Part V Division 3 of the Environmental Protection Act 1986

Works Approval Number W2976/2025/1

File number APP-0027550

Premises Lot 4, 10 Binningup Road

Figure 1: Distance to sensitive receptors

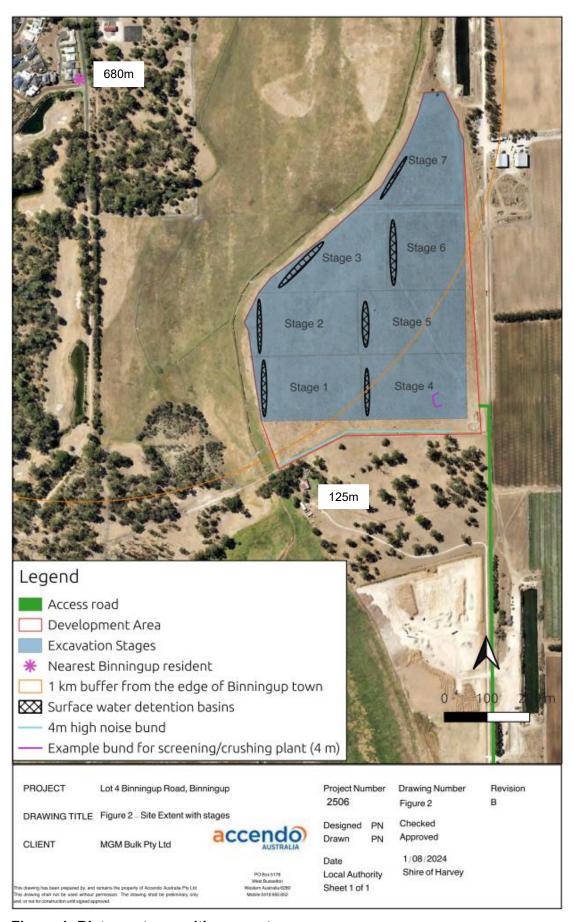
Figure / Section	Summary of applicant's comment	Department's response	
Figure 2 – Works Approval	The applicant has requested the removal of Figure 2 of the draft documents as the staging is no longer relevant.	The Delegated Officer notes and accepts the request. Figure 2 has been removed. Figure 1 remains as the staging is displayed correctly.	
Schedule 2 – Works Approval	The applicant was requested to provide the coordinates of the prescribed premises boundary.	The coordinates of the prescribed premises boundary were provided by the applicant and recorded in Schedule 2 of the Works Approval.	
Section 2.4 of Decision Report – Other Approvals	The applicant advised that the Extractive Industries Licence [A2367/EX/007] has been extended to expire on 06 December 2029.	The Delegated Officer notes and accepts the request. The expiry date has been updated to reflect the new date.
